# RealSense™ Product Family

## D500 Series

Specification Update

Revision 002

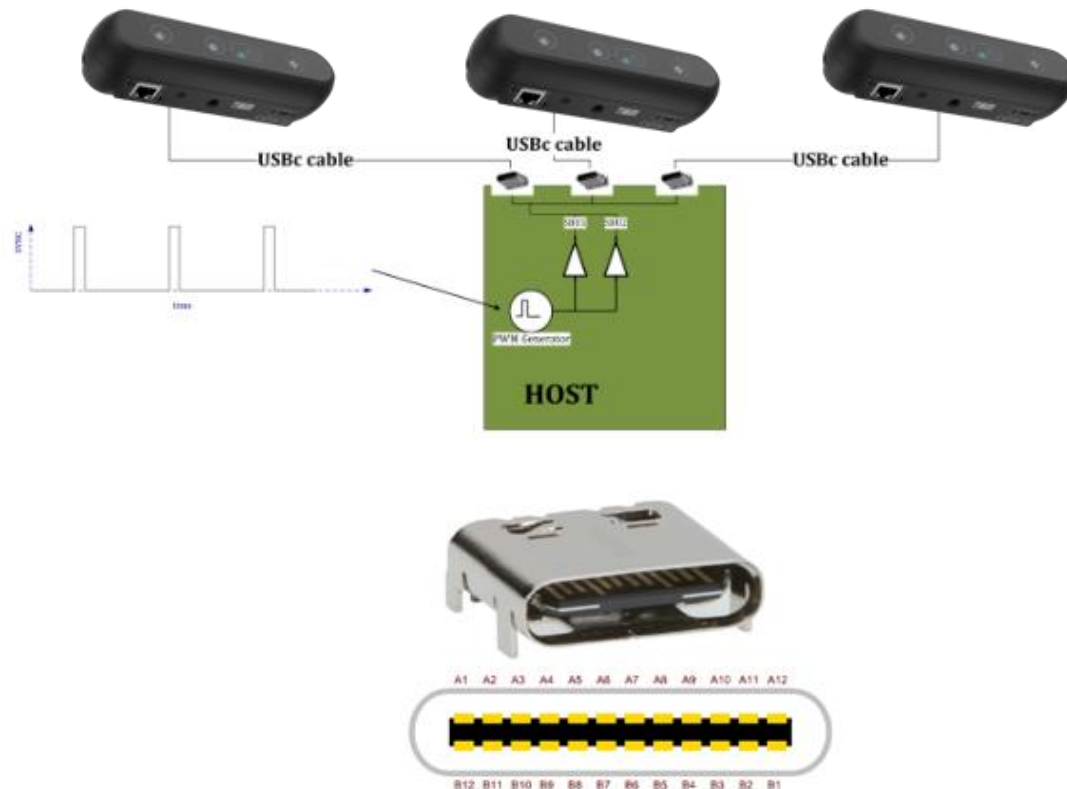
<b>RSDEV-3188</b>	<b>~0.5pixel UV movement to the right for both X and Y axis</b>
<b>Problem:</b>	The calibration conventions in D555 differs from D4xx. In D4xx devices the origin of the pixel is the upper left corner, while in D555 it is the center of the pixel.
<b>Implication:</b>	Texture map misalignment by 0.5 pixel horizontally and vertically in registered depth and texture PointCloud scenarios
<b>Workaround:</b>	None. Users can use external tools/libraries for Texture Mapping
<b>Status:</b>	Refer the <i>Summary Tables of Changes</i>
